Monitoring Year 4 FINAL Monitoring Report
Stewarts Creek Tributaries Stream Restoration Project
Surry County, North Carolina
Yadkin River Basin, Hydrologic Unit Code (HUC) 03040101

December 27, 2023

**RE: Response to Draft Monitoring Year 4 report for the Stewarts Creek Tributaries site
Yadkin River Basin – CU# 03040101 – Surry County DMS Project ID No. 100023.
Contract # 7183**

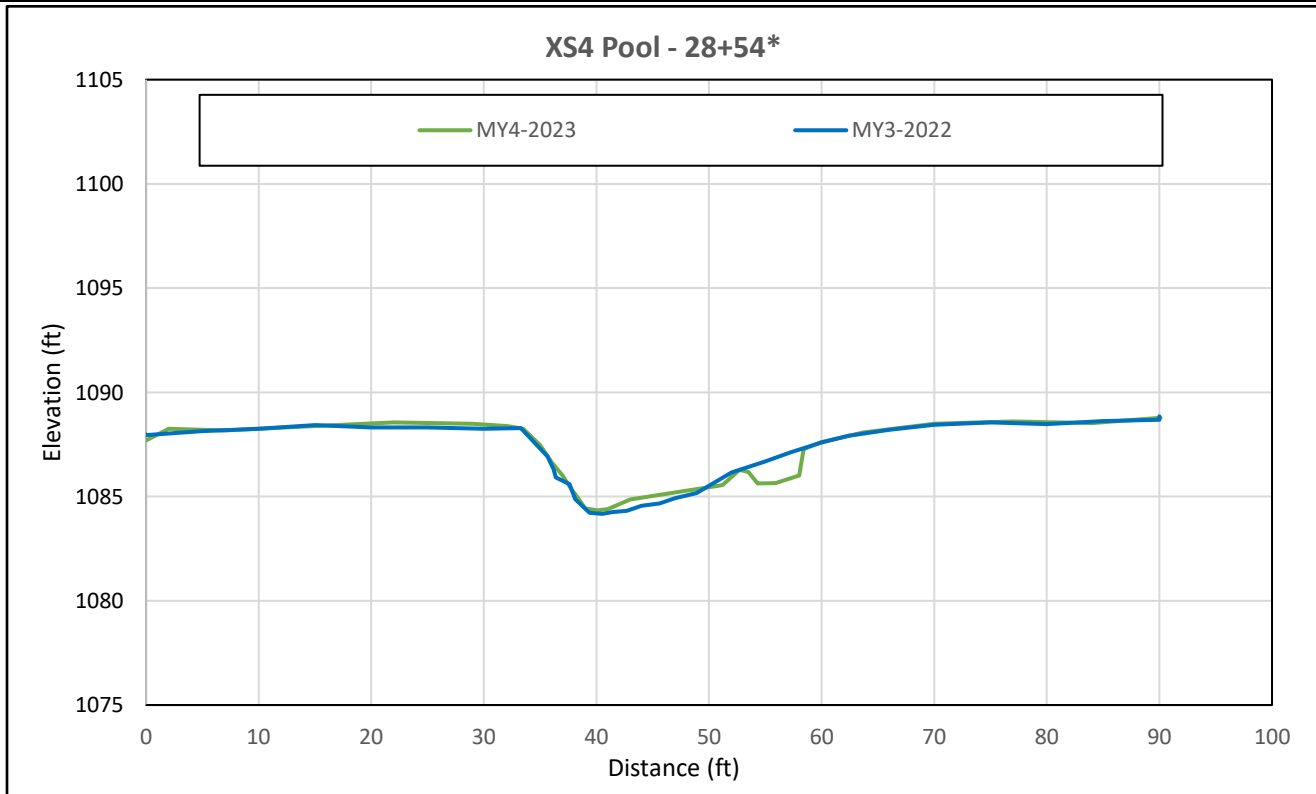
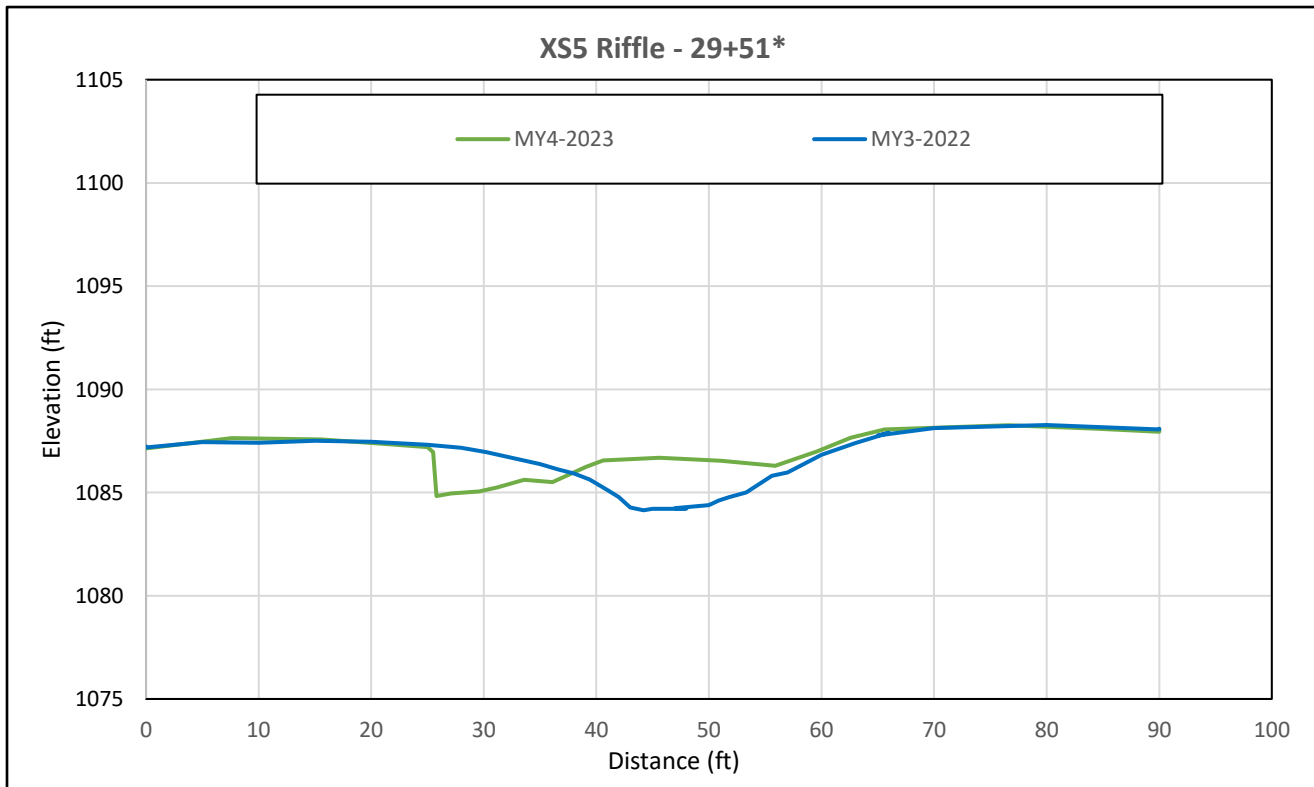
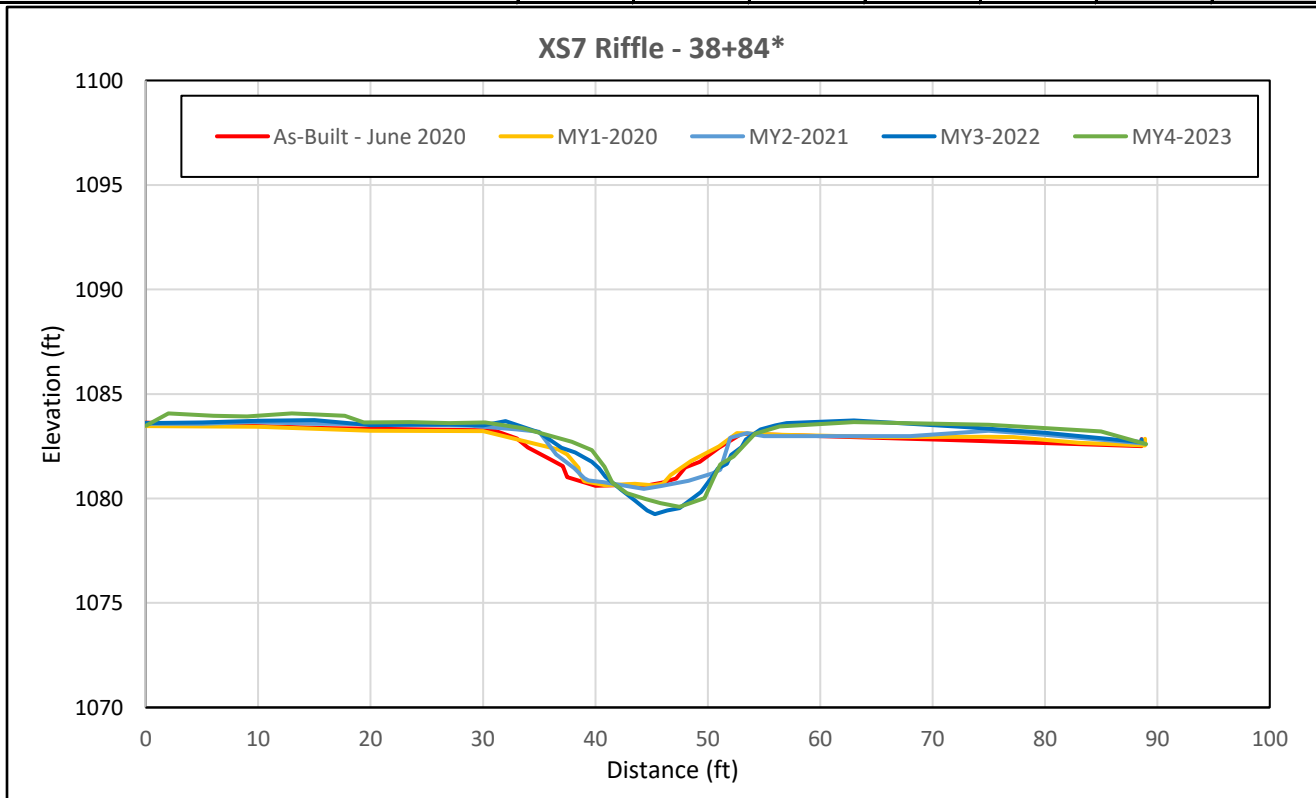
Cross Section Plots XS4 - Moores Fork Reach 2; XS5 - Moores Fork Reach 2; XS7 - Moores Fork Reach 2: Please update the graphs so the plot lines (MY3 & MY4) are different colors and distinguishable.

- **The colors in the cross-section plots have been updated to distinguish between monitoring years.**
